I, GILBERT ALDAZ, NMPE 10848, OF THE FIRM APPLIED ENGINEERING & SURVEYING, INC., HEREBY CERTIFY THAT THIS PROJECT HAS BEEN GRADED AND WILL DRAIN IN SUBSTANTIAL COMPLIANCE WITH AND IN ACCORDANCE WITH THE DESIGN INTENT OF THE APPROVED PLAN DATED SEPTEMBER 7, 2010. THE RECORD INFORMATION EDITED ONTO THE ORIGINAL DESIGN DOCUMENT HAS BEEN OBTAINED BY GILBERT ALDAZ, NMPE 10848, OF THE FIRM APPLIED ENGINEERING & SURVEYING, INC. I FURTHER CERTIFY THAT I HAVE PERSONALLY VISITED THE PROJECT SITE ON JANUARY 19, 2012 AND HAVE DETERMINED BY VISUAL INSPECTION THAT THE SURVEY DATA PROVIDED IS REPRESENTATIVE OF ACTUAL SITE CONDITIONS AND IS TRUE AND CORRECT TO THE BEST OF MY KNOWLEDGE AND BELIEF. THIS CERTIFICATION IS SUBMITTED IN SUPPORT OF A REQUEST FOR CERTIFICATION OF OCCUPANCY.

NM EDUCATORS PARKING LOT
ALBUQUERQUE, NEW MEXICO

PROPOSED GRADING/DRAINAGE IMPROVEMENTS

DRAINAGE AND GRADING PLAN

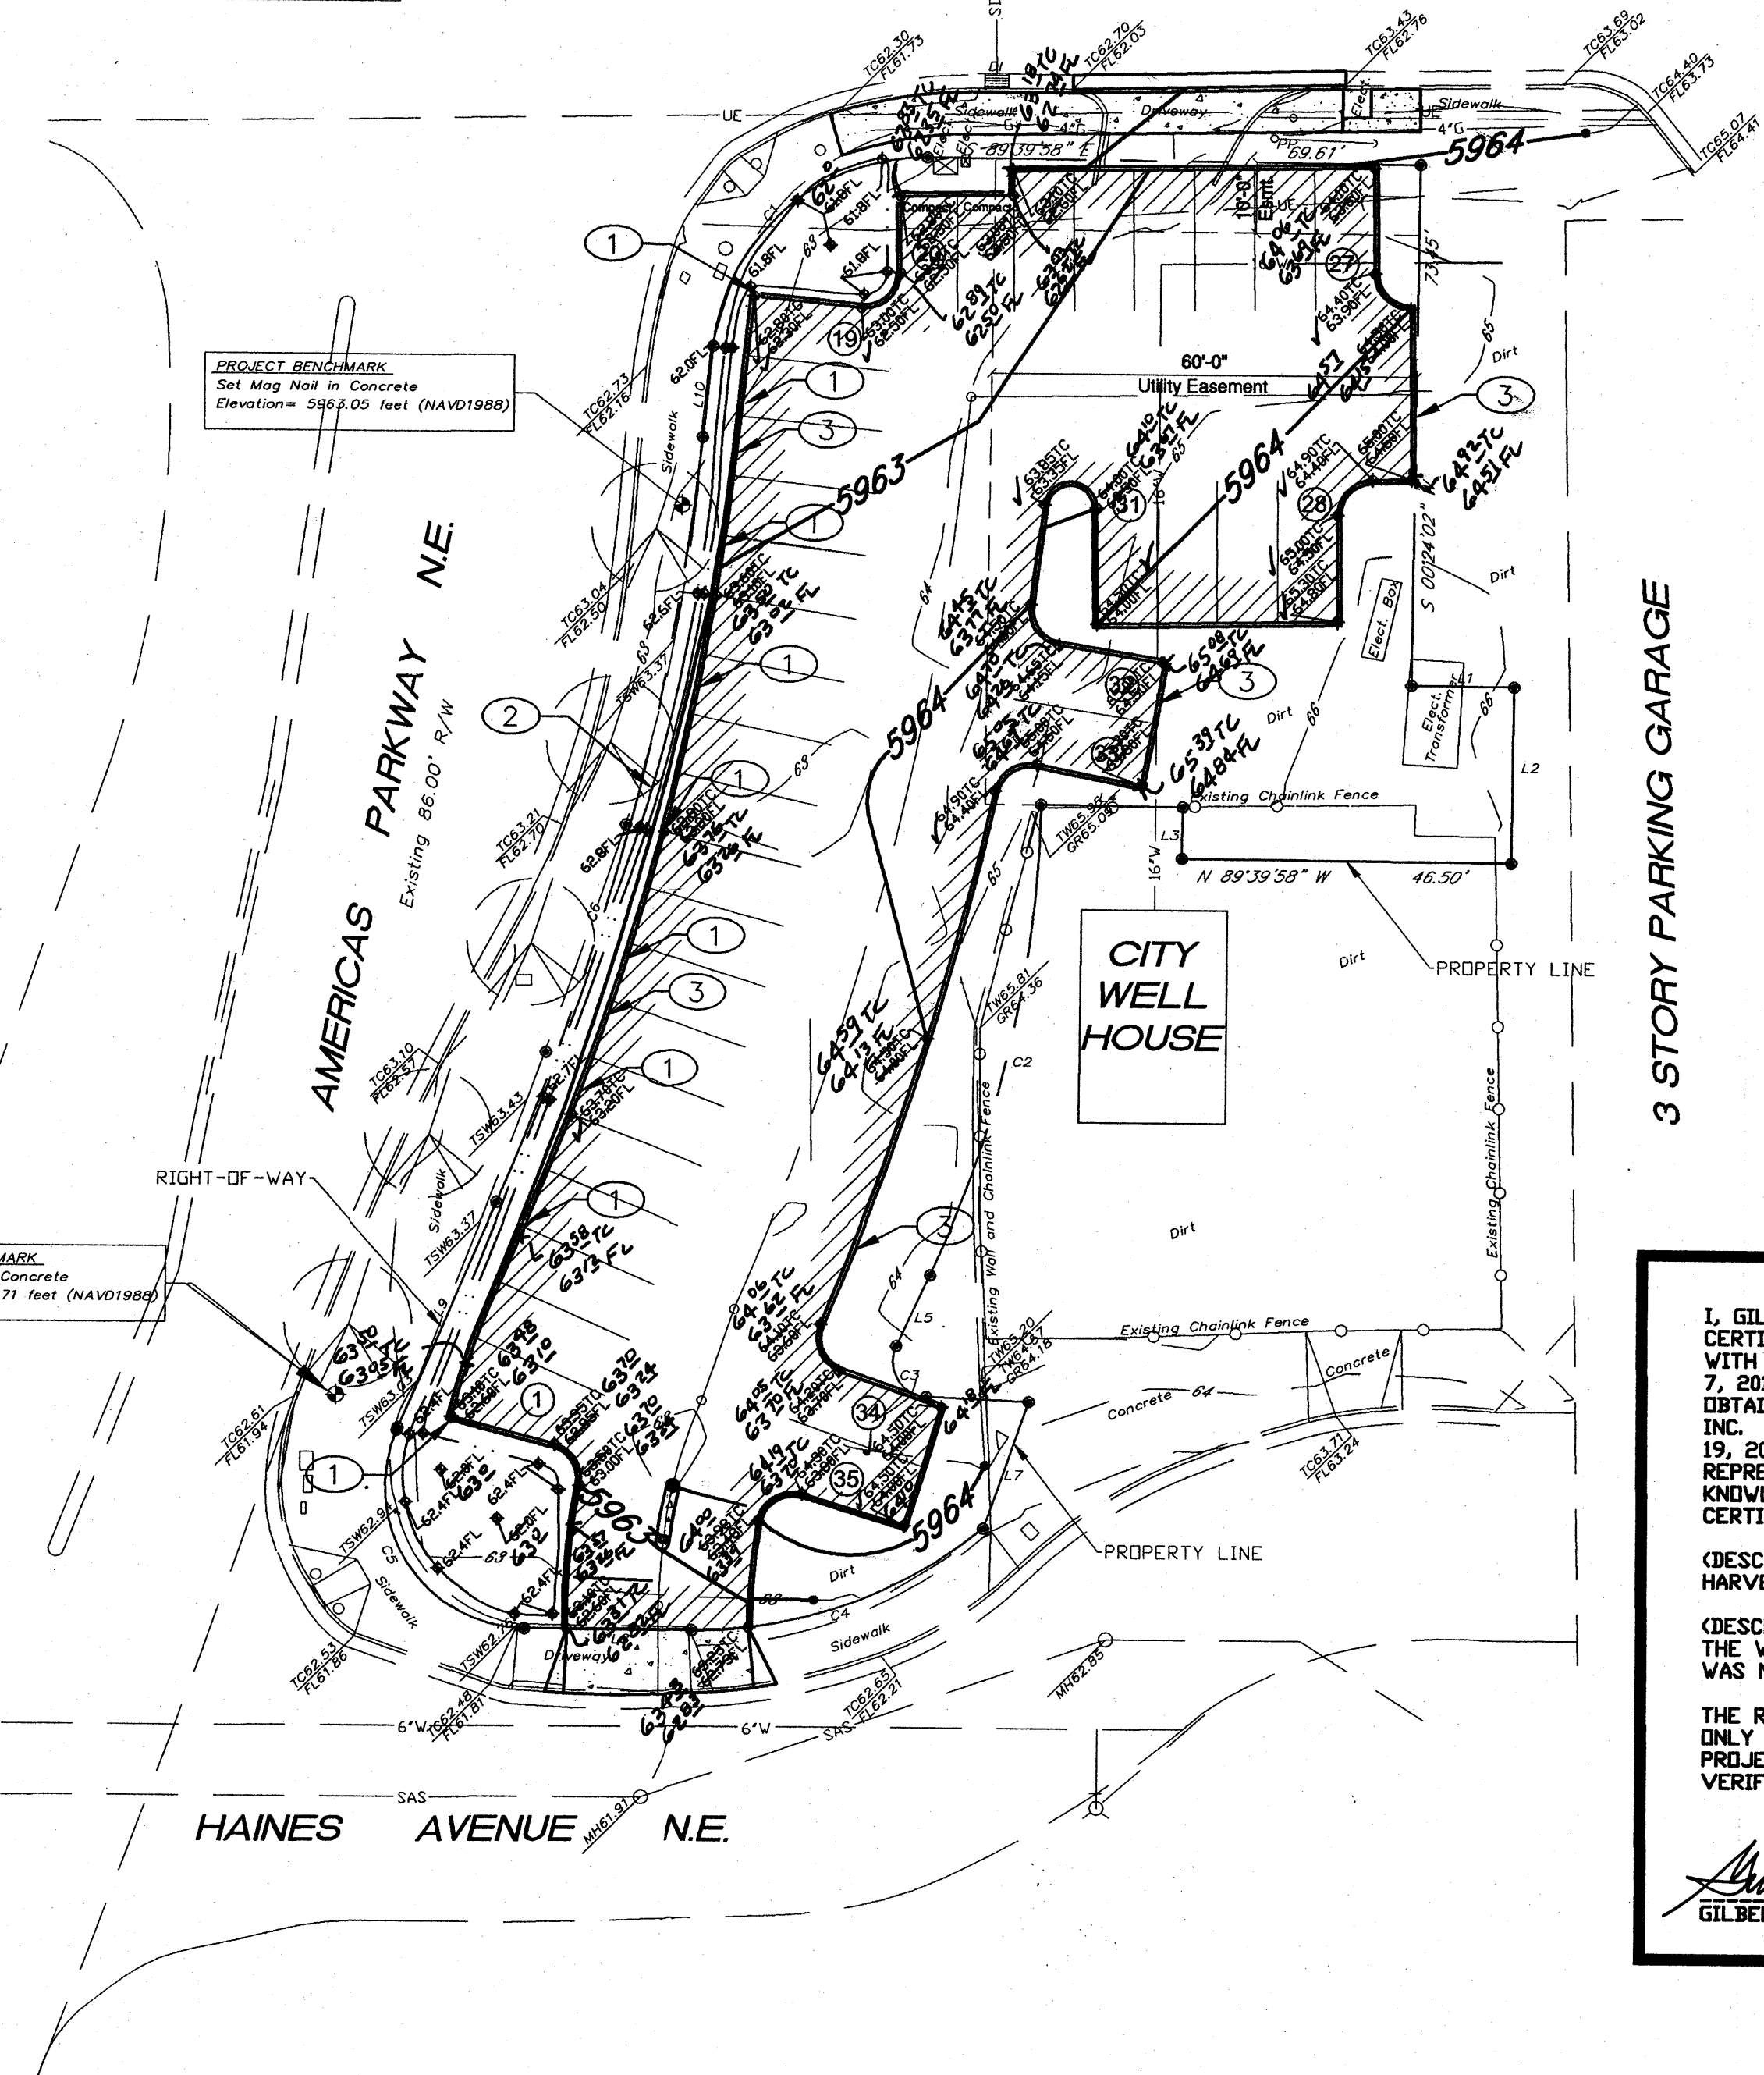
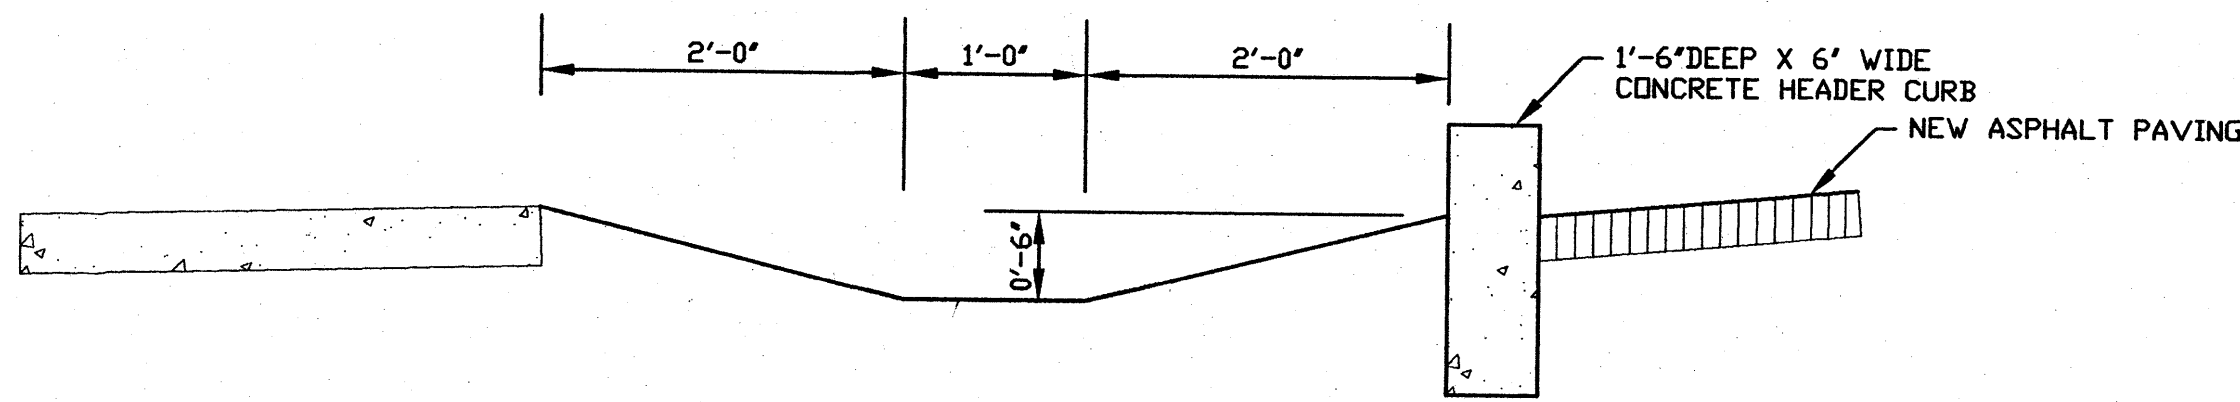
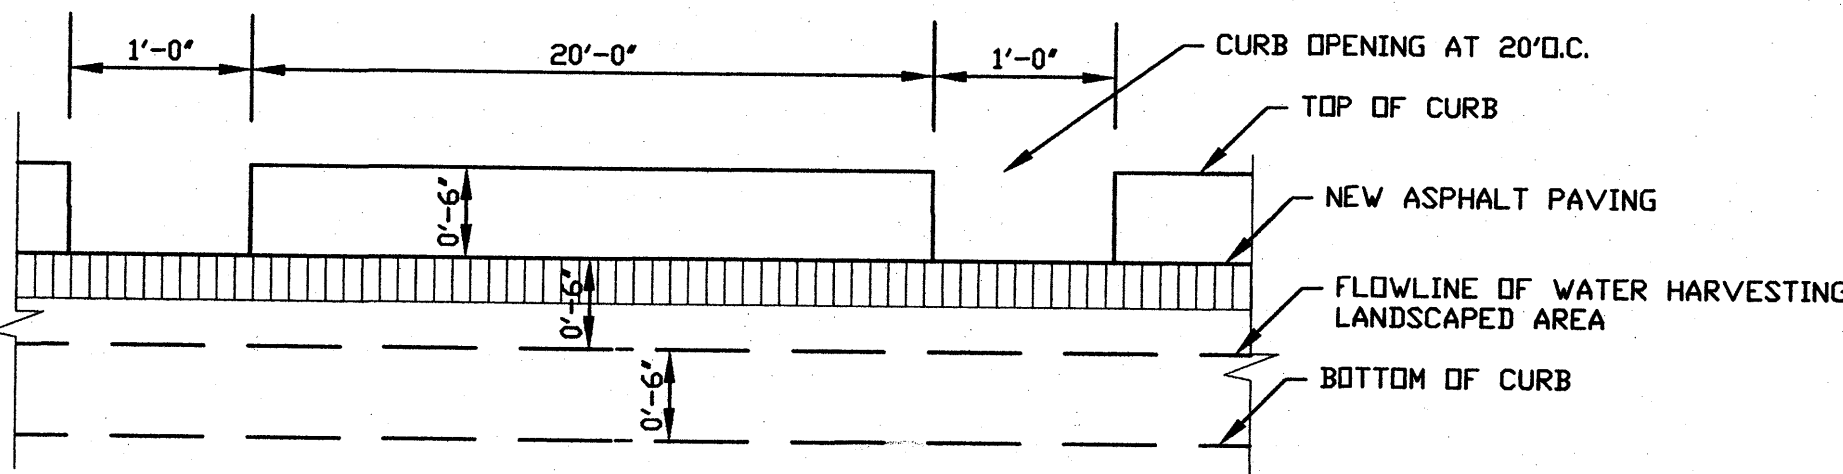
(DESCRIBE ANY EXCEPTIONS AND/OR QUALIFICATIONS HERE IN A SEPARATE PARAGRAPH) WATER HARVESTING PONDING NOT IMPLEMENTED AT SOUTHWEST CORNER OF SITE.

(DESCRIBE ANY DEFICIENCIES AND/OR REQUIRED CORRECTIONS HERE IN A SEPARATE PARAGRAPH) THE WATER HARVESTING DEFICIENCY DOES NOT IMPACT DOWNSTREAM CAPACITY SINCE PONDING WAS NOT REQUIRED FOR THIS DEVELOPMENT.
